Form 3160-5
(June 2019)

SUNDRY NOTICES AND REPORTS ON WELLS
Do not use this form for proposals to drill or to re-enter an abandoned well. Use Form 3160-3 (APD) for such proposals.

8. Well Name and No. ROSS DRAW 17 FED COM/711H

EOG respectfully requests an amendment to our approved APD for this well to reflect the following changes:

WELL LOCATION AND ACREAGE DEDICATION PLAT

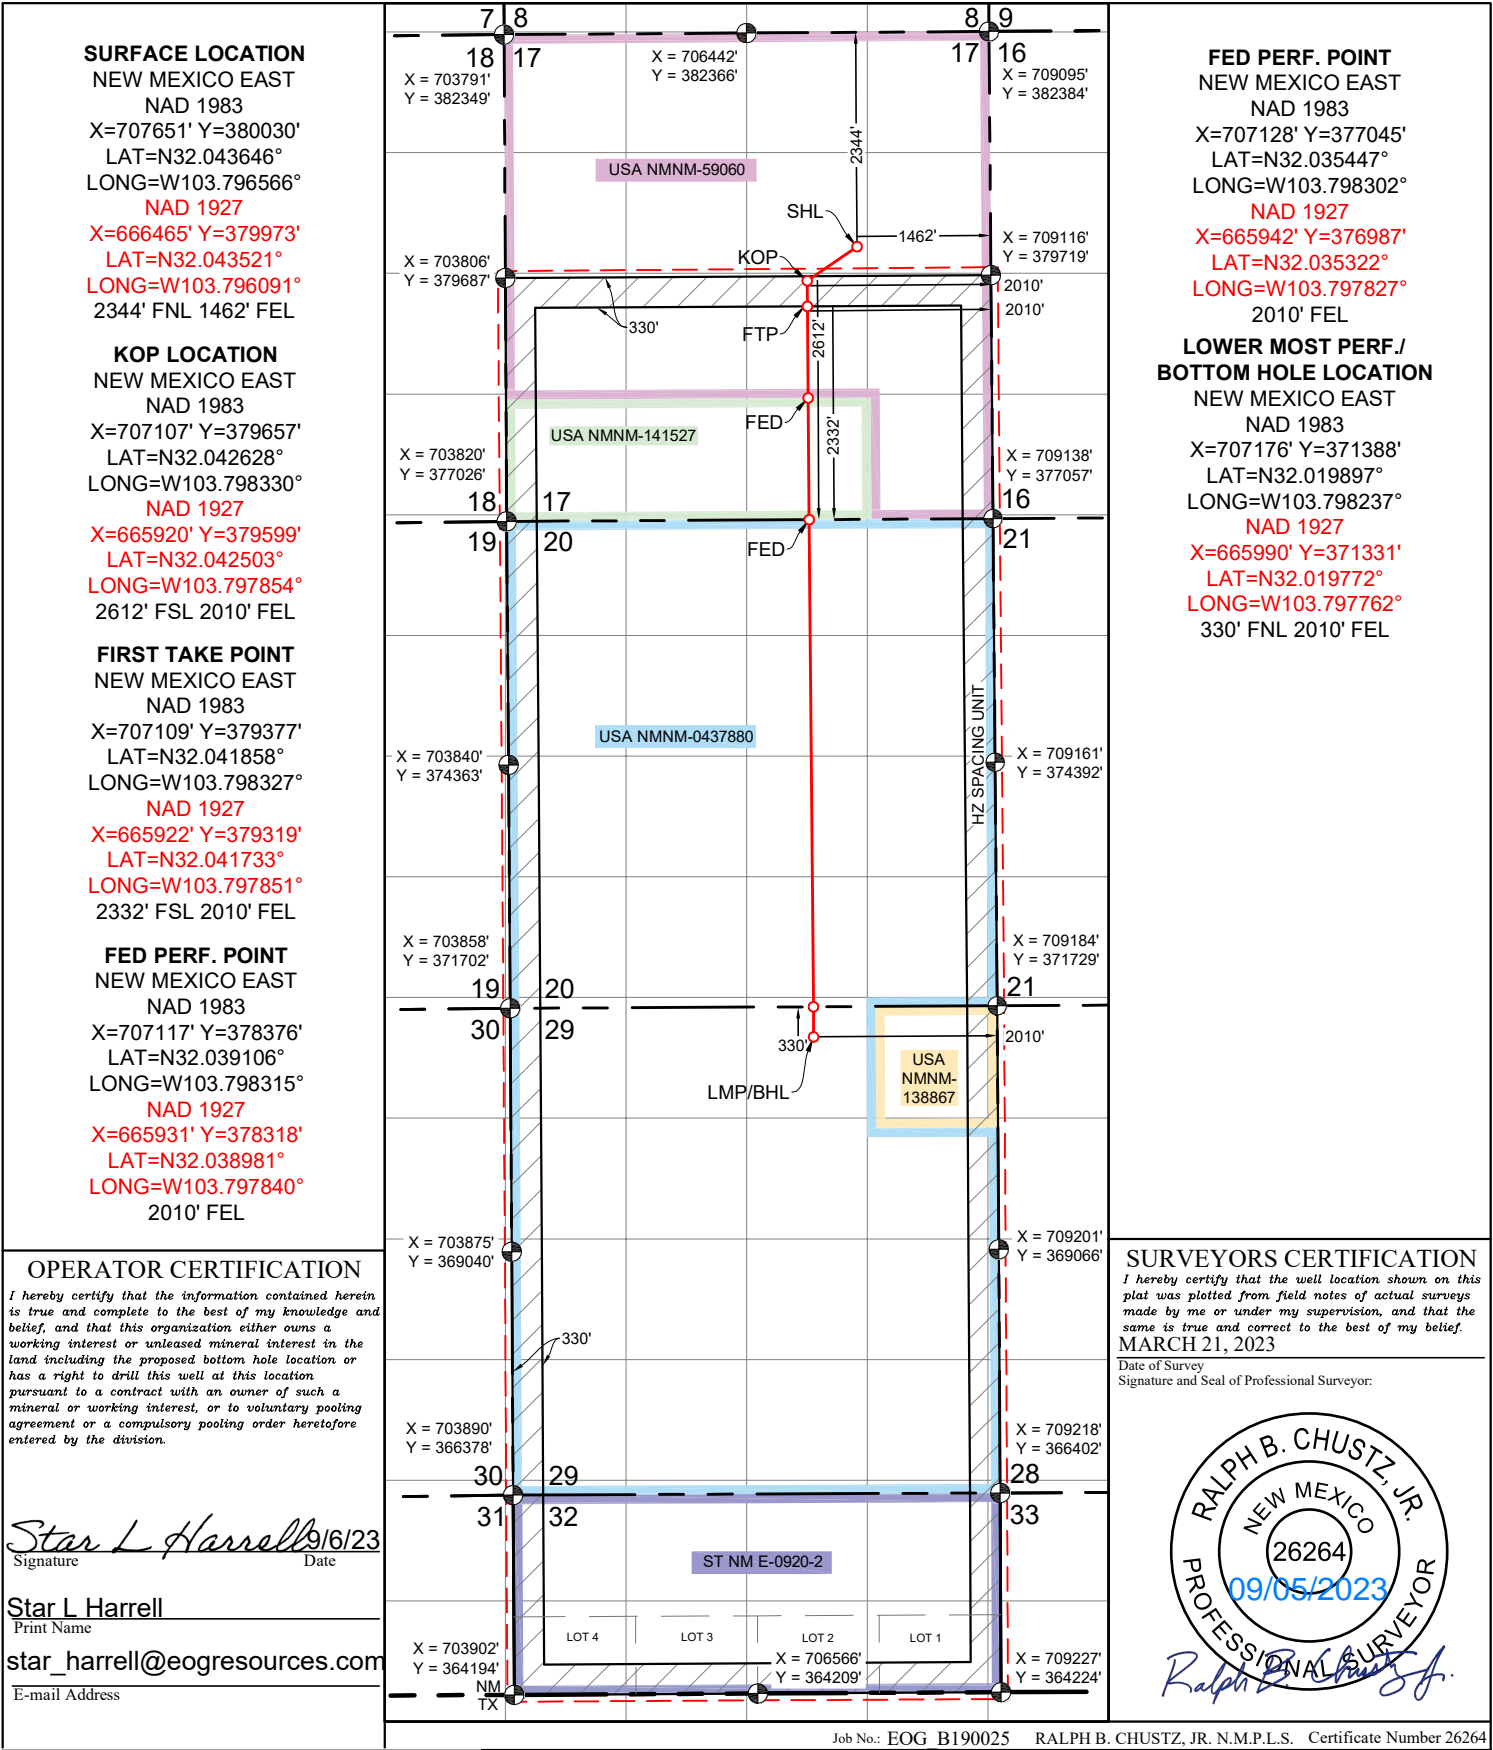
Change SHL from T-26-S, R-31-E, Sec 17, 2475' FNL, 1723' FWL, Eddy Co., NM, to T-26-S, R-31-E, Sec 17, 2344' FNL, 1462' FEL, Eddy Co., N.M.

Change BHL from T-26-S, R-31-E, Sec 8, 230' FNL, 1650' FWL, Eddy Co., NM, to T-26-S, R-31-E, Sec 29, 330' FNL, 2010' FEL, Eddy Co., N.M.

Update HSU to 1862 acres.

UL or lot no.	Section	Township	Range	Lot Idn	Feet from the	North/South line	Feet from the	East/West line	County
G	17	26 S	31 E		2344	NORTH	1462	EAST	EDDY

UL or lot no.	Section	Township	Range	Lot Idn	Feet from the	North/South line	Feet from the	East/West line	County
B	29	26 S	31 E		330	NORTH	2010	EAST	EDDY

Dedicated Acres 1862	Joint or Infill	Consolidated Code	Order No. PENDING NSP & PENDING COM AGREEMENT
-------------------------	-----------------	-------------------	--

Revised Wellbore

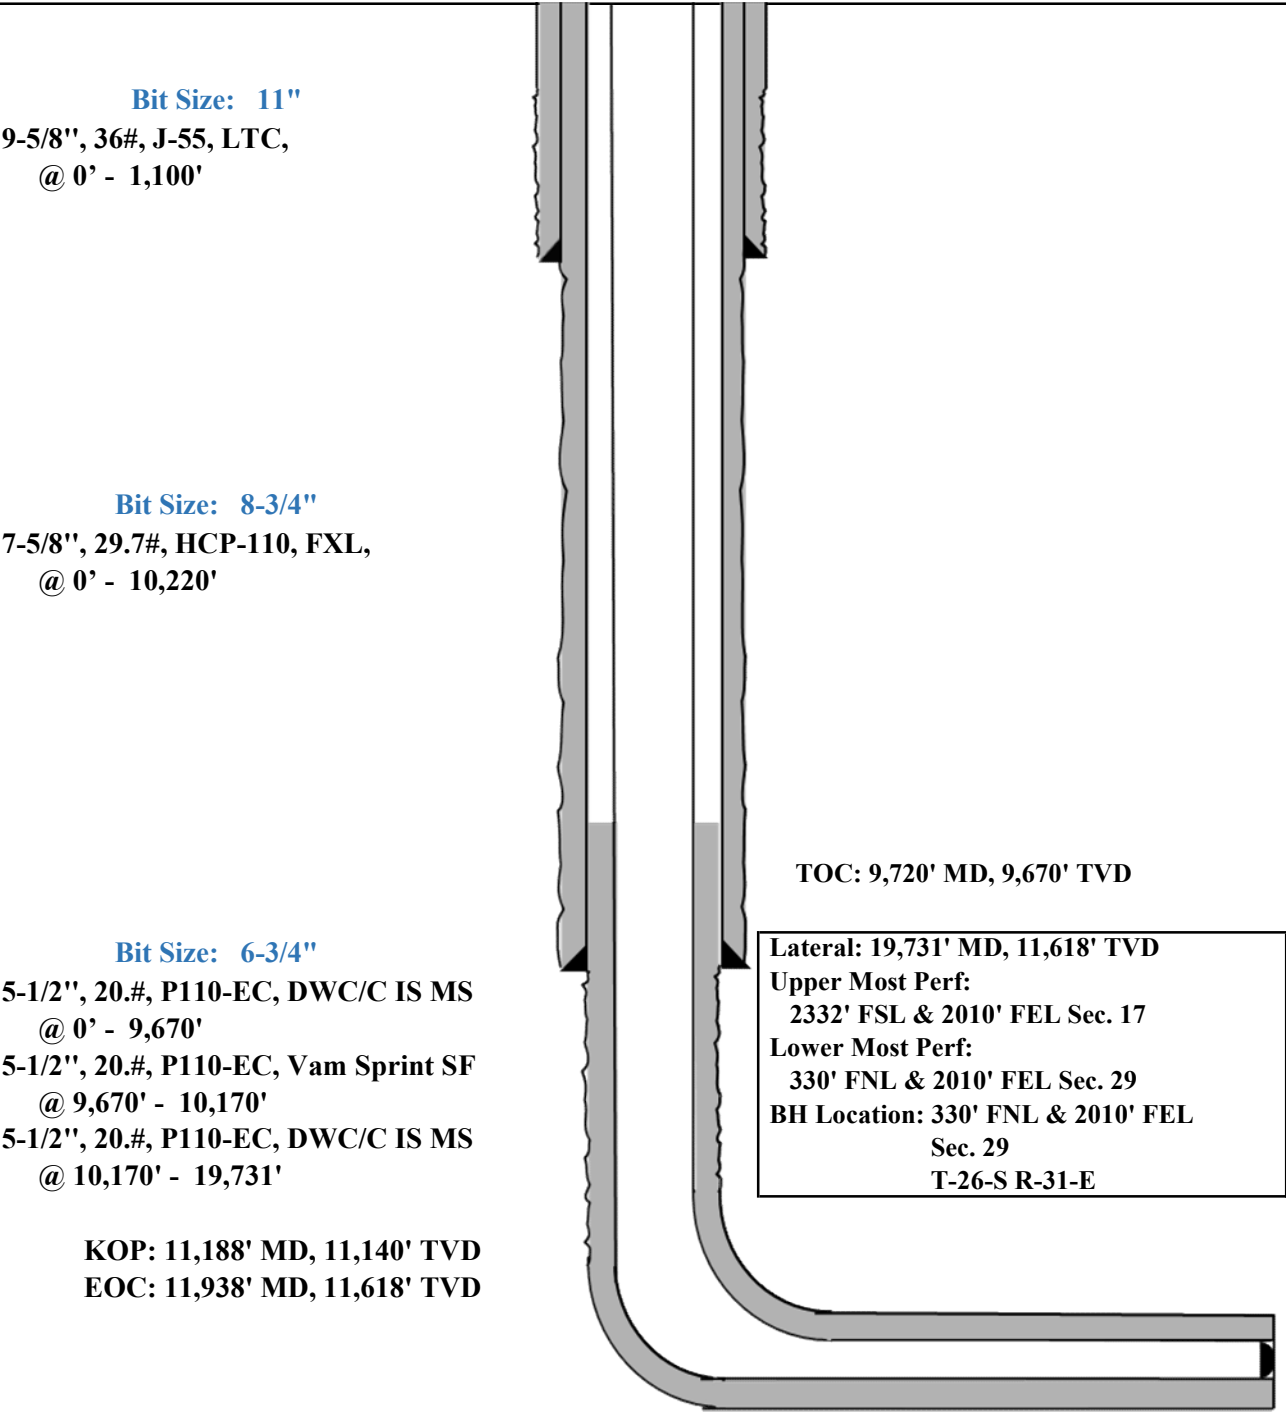
Update casing and cement program to current design.

Hole Size	Interval MD		Interval TVD		Csg OD	Weight	Grade	Conn
	From (ft)	To (ft)	From (ft)	To (ft)				
11"	0	1,100	0	1,100	9-5/8"	36#	J-55	LTC
8-3/4"	0	10,220	0	10,170	7-5/8"	29.7#	HCP-110	FXL
6-3/4"	0	9,720	0	9,670	5-1/2"	20#	P110-EC	DWC/C IS MS
6-3/4"	9,720	10,220	9,670	10,170	5-1/2"	20#	P110-EC	Vam Sprint SF
6-3/4"	10,220	19,731	10,170	11,618	5-1/2"	20#	P110-EC	DWC/C IS MS

Variance is requested to waive the centralizer requirements for the 7-5/8" casing in the 8-3/4" hole size. An expansion additive will be utilized, in the cement slurry, for the entire length of the 8-3/4" hole interval to maximize cement bond and zonal isolation.

Variance is also requested to waive any centralizer requirements for the 5-1/2" casing in the 6-3/4" hole size. An expansion additive will be utilized, in the cement slurry, for the entire length of the 6-3/4" hole interval to maximize cement bond and zonal isolation.

Variance is also requested to waive the annular clearance requirements for the 5-1/2" casing by 7-5/8" casing annulus to the proposed top of cement.
